ETC® Release Note

Eos®/ Ion™ Lighting Control Family Software

Version 1.4.3 software

500004791

Key-Cap Update

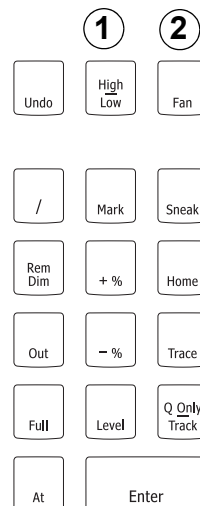
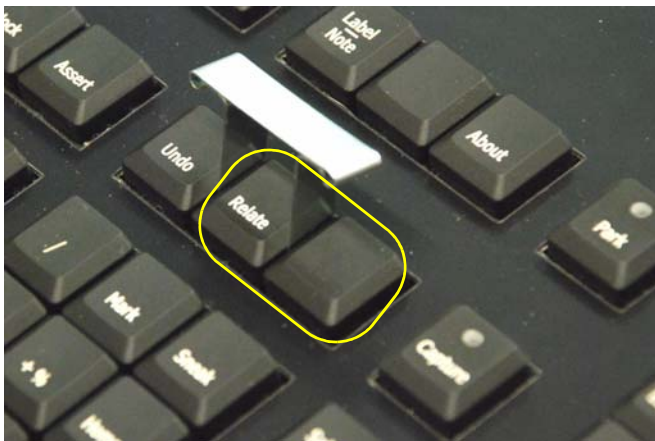
From Eos v1.3.1 to v1.4.x, two keys have been re-mapped and require that you change the physical keys on the console keyboard to match the software.

- Step 1: Use the key puller provided to remove the two keys shown below in the order indicated below.
- Step 2: Place the keys in their new correct locations and press them down firmly.
- “High/Low” replaces “Relate and “Fan” replaces the blank key.

Below is the correct orientation to use
the key puller for these keys.
Remove "Relate" and the adjacent
blank key.

Remove the keys in the order shown by the numbers next to each location.

This is the correct final position for the keys.
 "High/Low" replaces "Relate".
 "Fan" replaces blank.
